**ADDENDUM NO. 1**
**TO CONTRACT DOCUMENTS FOR**
**WATERSHEDS ASSET REHABILITATION PROGRAM (WARP)**
**UVAS CREEK LEVEE REHABILITATION PROJECT PHASE 2**
**Project No. 62084001 Task No. 5175 Contract No. C0648**

**WATERSHEDS ASSET REHABILITATION PROGRAM (WARP)**

**ADDENDUM 1**

**REVISED DRAWINGS**

PROJECT NUMBER: 62084001
SHEET CODE: 1 G-02
SHEET NUMBER: 2 OF 32

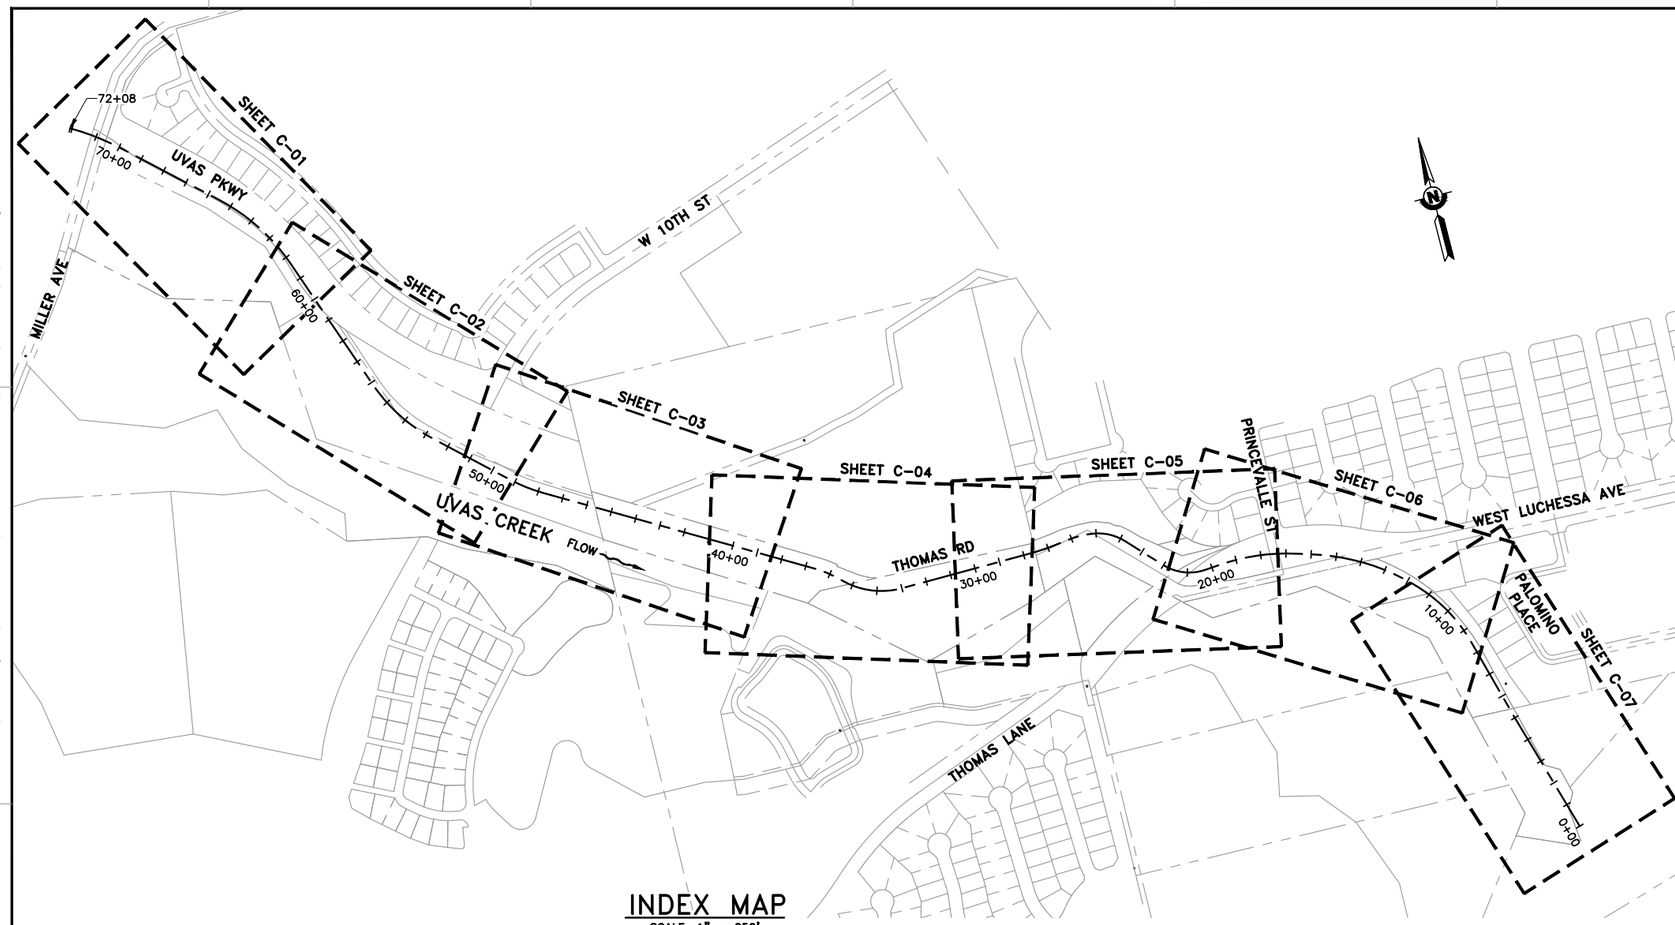
| REV | DESCRIPTION | DATE | APPR | REFERENCE INFORMATION AND NOTES |
|---|---|---|---|---|
| 1 | ADDENDUM #1 – WORK AREA RESTRICTION | 5/1/19 | TI | |

SHEET CODE: 1
C-02

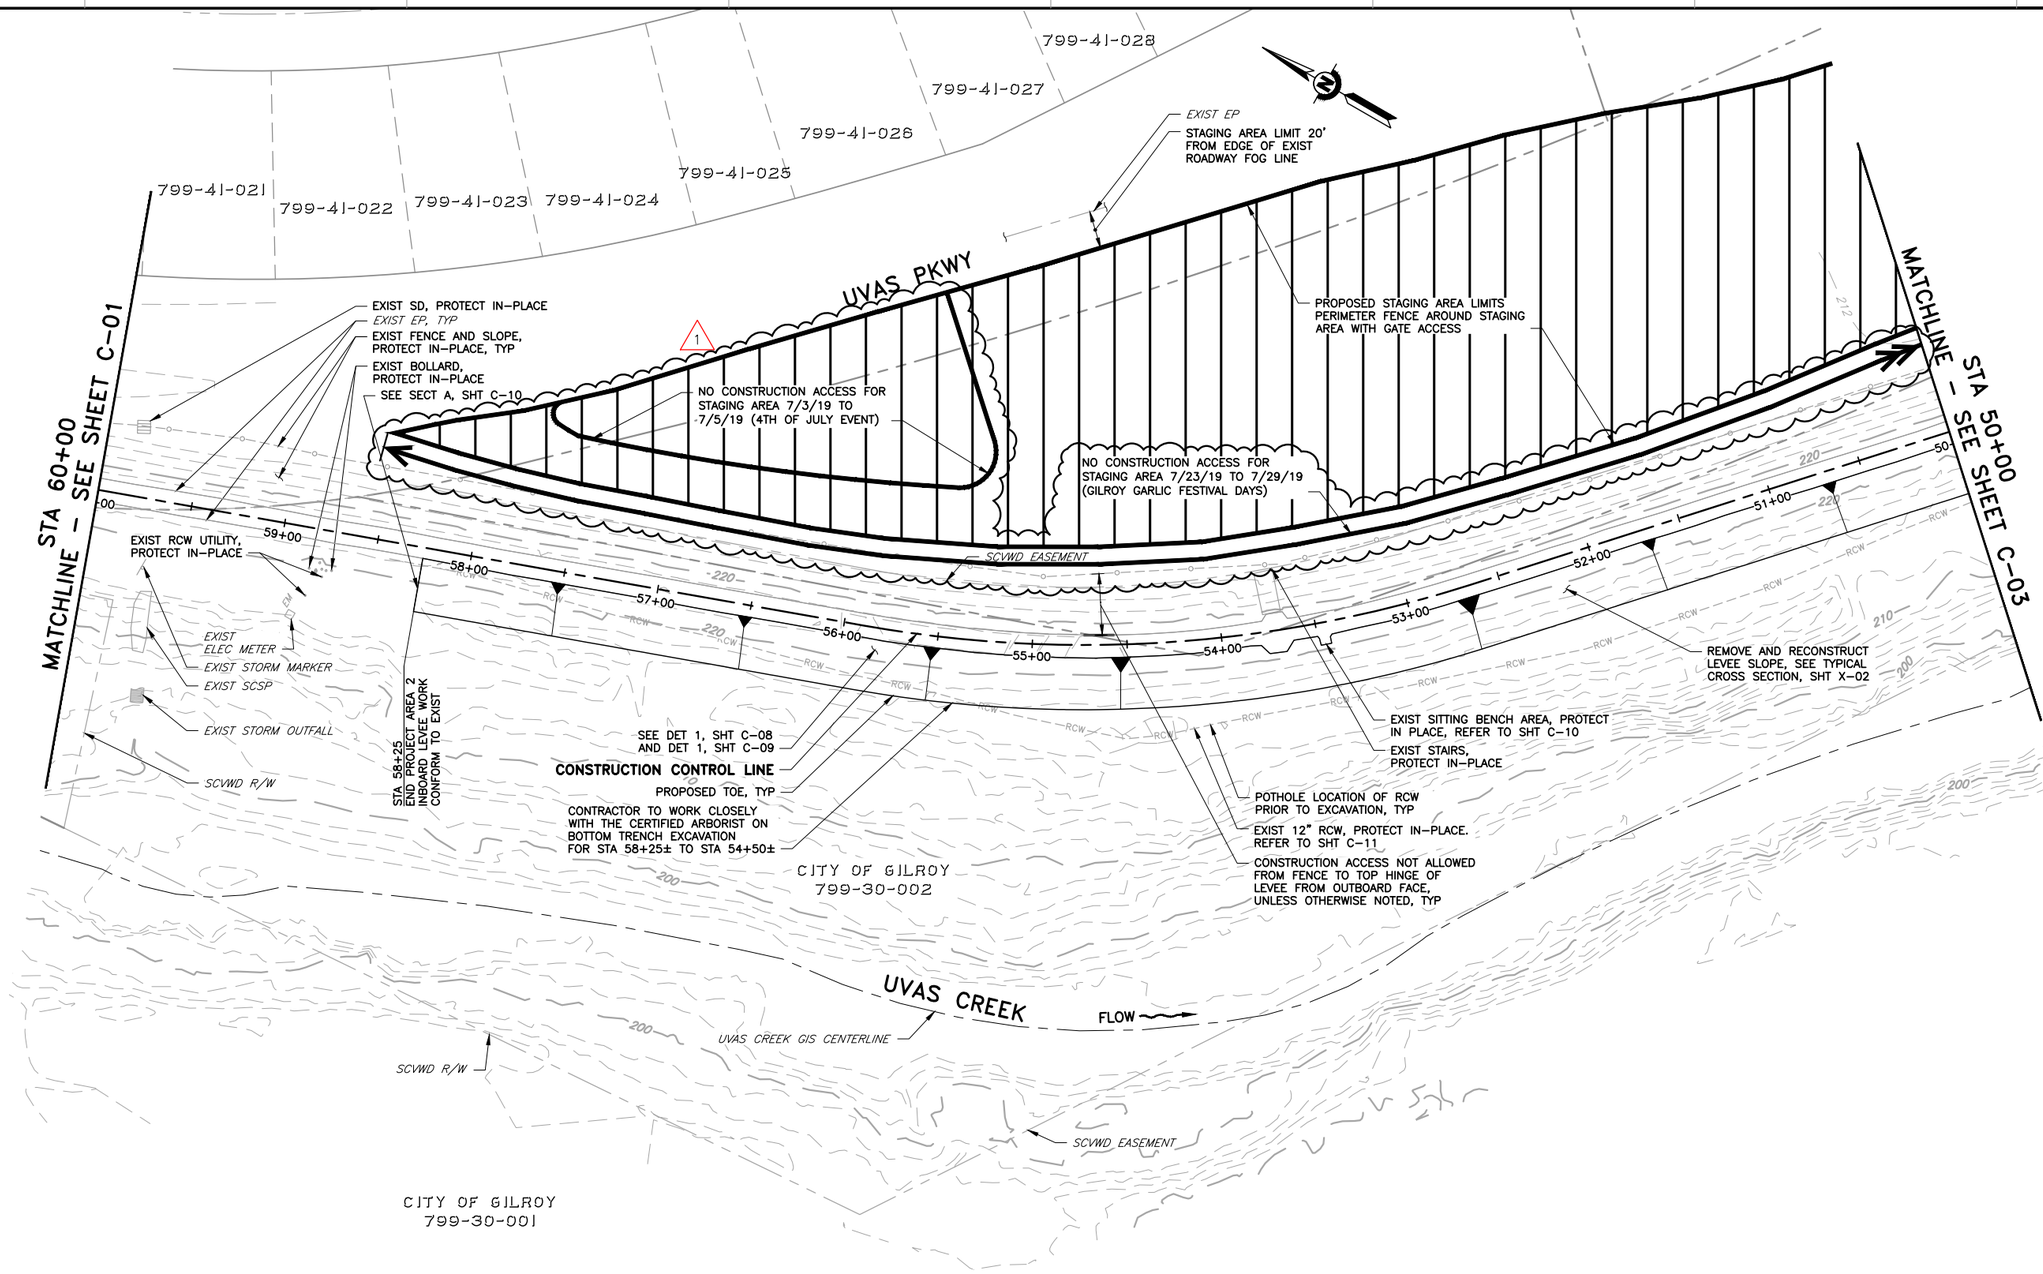
"E. In consideration of the City's Fourth of July festivities and activities, absolutely **NO** construction work shall be allowed to be performed from July 3, 2019 through July 5, 2019. Additionally, in consideration of the City of Gilroy's Garlic Festival Days of July 26 through July 28, 2019, **NO** construction work shall be allowed to be performed from July 23, 2019 through July 29, 2019. Reference is made to Plan Sheets C-02 and C-03 regarding construction area restrictions during the indicated restricted dates."

| REV | DESCRIPTION | DATE | APPR |
|---|---|---|---|
| 1 | ADDENDUM #1 – WORK AREA RESTRICTION | 5/1/19 | TI |

PROJECT NUMBER: 62084001
SHEET CODE: 1 C-03
SHEET NUMBER: 20 OF 32

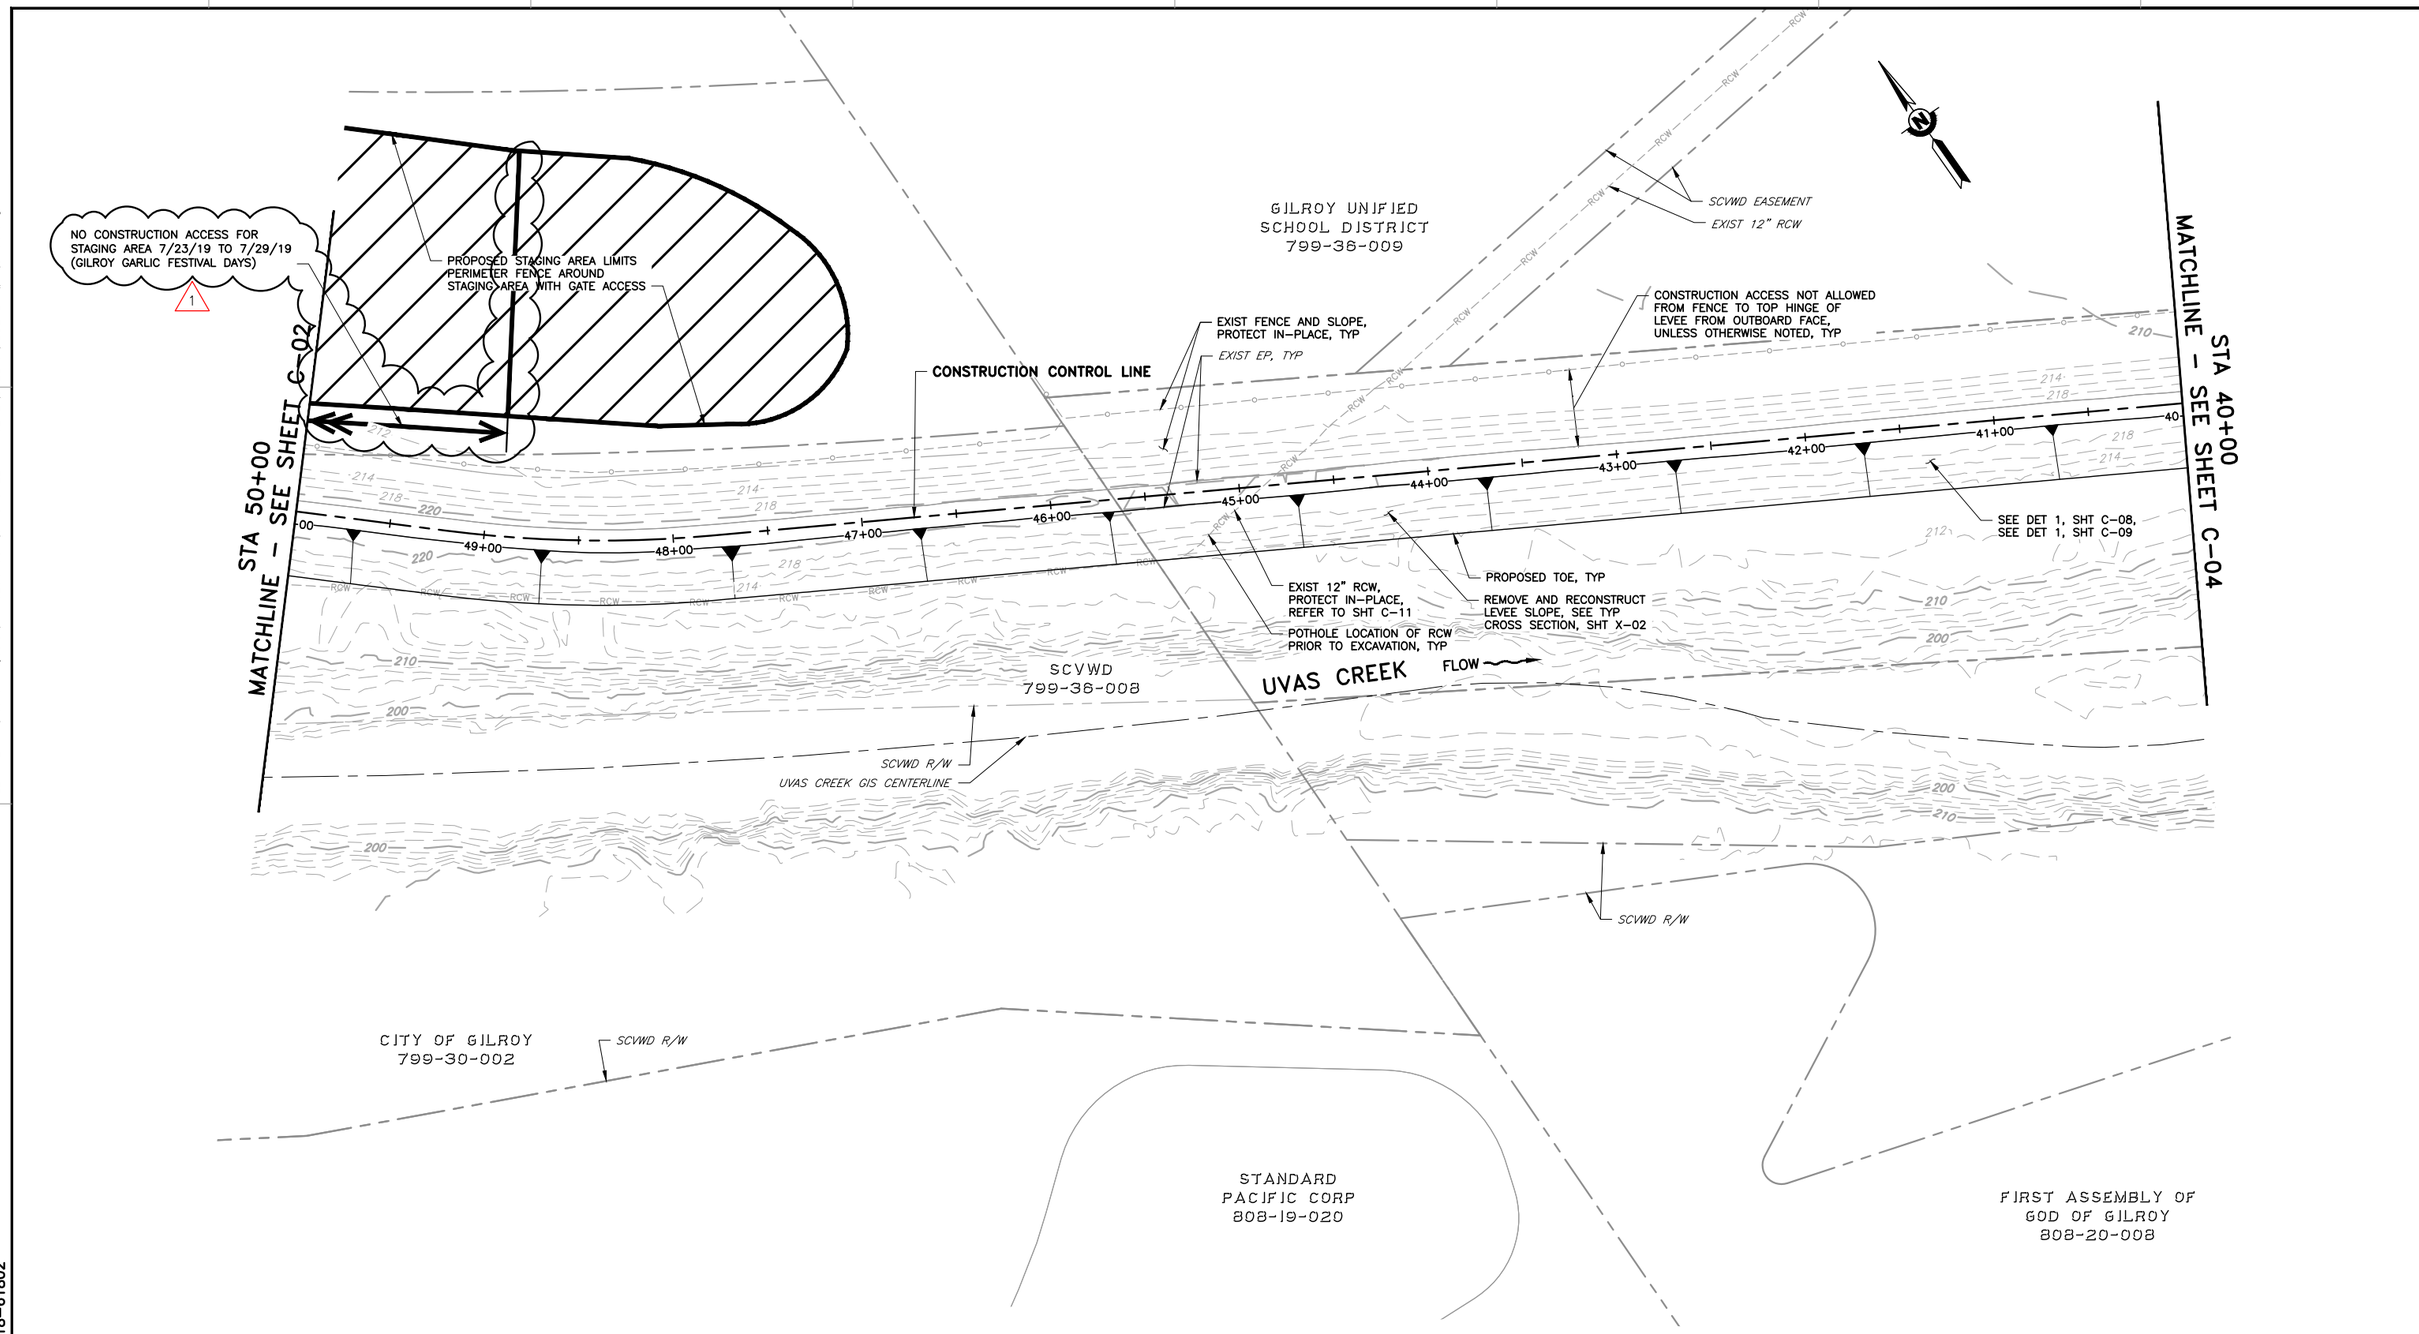
| REV | DESCRIPTION | DATE | APPR |
|---|---|---|---|
| 1 | ADDENDUM #1 – WORK AREA RESTRICTION | 5/1/19 | TI |
